**Strategic regional water  
resource solutions:**

**Accelerated gate two final  
decision for desalination**

**Ofwat**

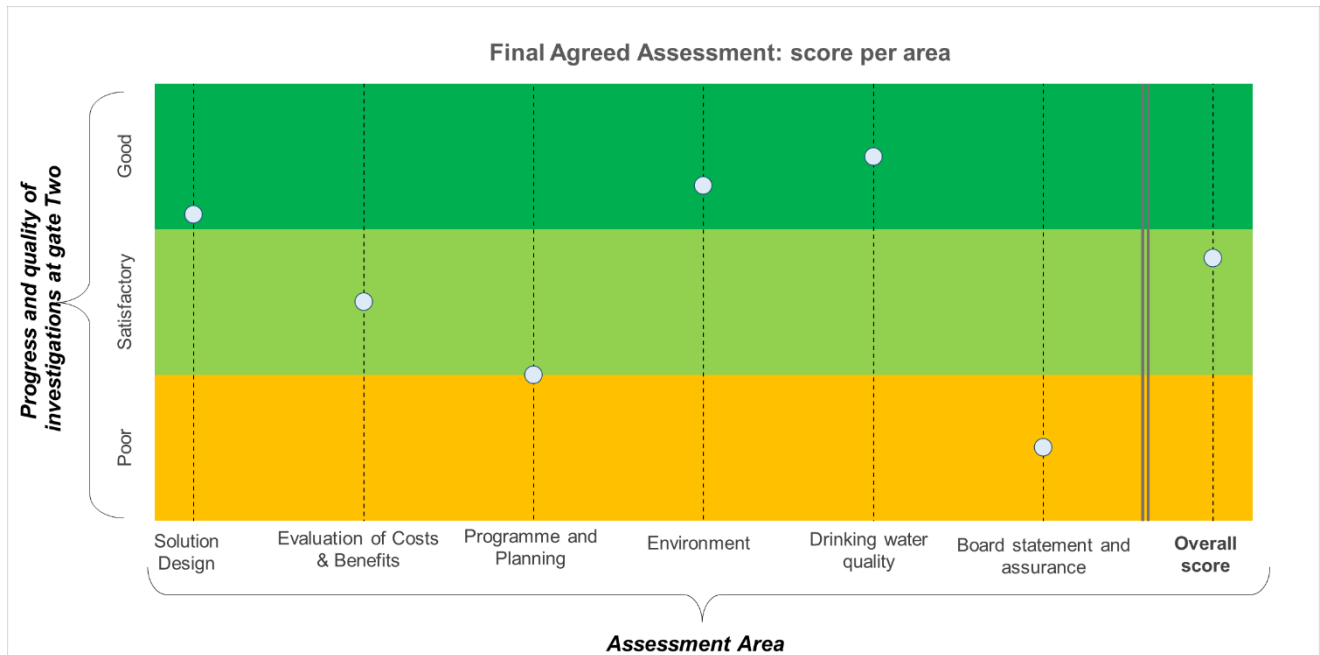
We have identified two areas where we consider submitted evidence has not been sufficient to justify efficient and allowed spend within the accelerated gate two programme of works. These are programme and project management and legal costs.

Our adjustments detailed above for project management and legal costs reduce the amount claimed and allowed to £4.69m.

We will reassess these adjustments at standard gate two when additional cost benchmarks become available from the standard gate solutions.
